SERVICE BULLETIN

APPLICABILITY: 2017-18MY Impreza
2018MY Crosstrek

NUMBER: 07-123-17

SUBJECT: DTC B1661 / B1502, Change to Warning
Box Assembly

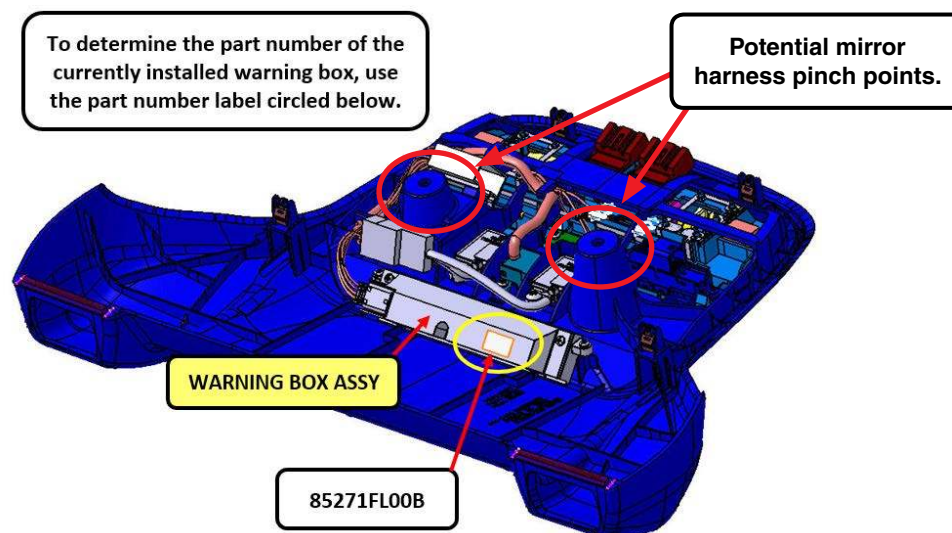
A design improvement has been made to the warning box assembly for improved responsiveness. The warning box is located inside the overhead map light assembly as shown in the illustrations below. The warning box part number has also been changed.

NOTE: This change also affects EyeSight camera covers (COVER ASSY ST CMR) and map lamps (LAMP ASSY MAP STD) because the warning box is included as part of these assemblies. Aside from the warning box improvement, there are no other changes to these two parts.

The part number for the new warning box assembly is **85271FL00B**.
